Question and Answer 1 regarding Lake George Library WAPs

Park County Public Libraries – Lake George

Wifi Access Points –Possible Locations/Installation Notes to aid in project

Lake George – 2 Access point recommended PoE

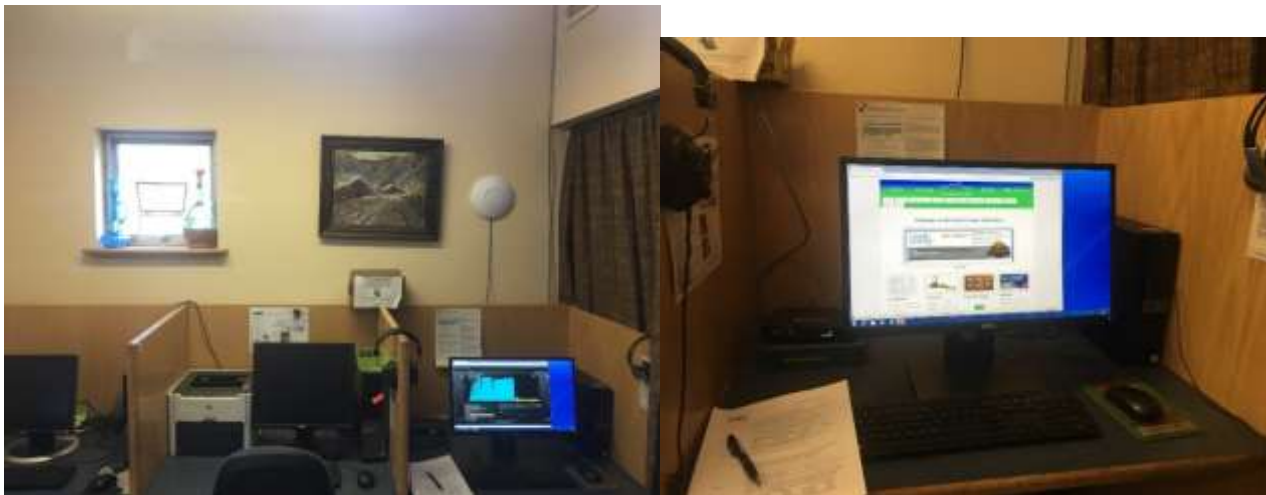
Question: On your RFPs and floor plans, I did not see markings to indicate potential locations for wireless access points. Can you identify locations for the wireless access points?

Answer: Below are the general evaluation results from an assessment done a couple of years ago for wireless access points in the four branches of Park County Public Library.

AP1 – Replace existing access point but use 20 foot cable to relocate around corner which should give the table area by windows better coverage. Or replace existing access point and use AP2 to accommodate meeting area and parking lot. No outlets or ethernet drops by those tables in meeting area.

AP2-Improved coverage for meeting area within building and parking lot area where patrons use WIFI extensively.
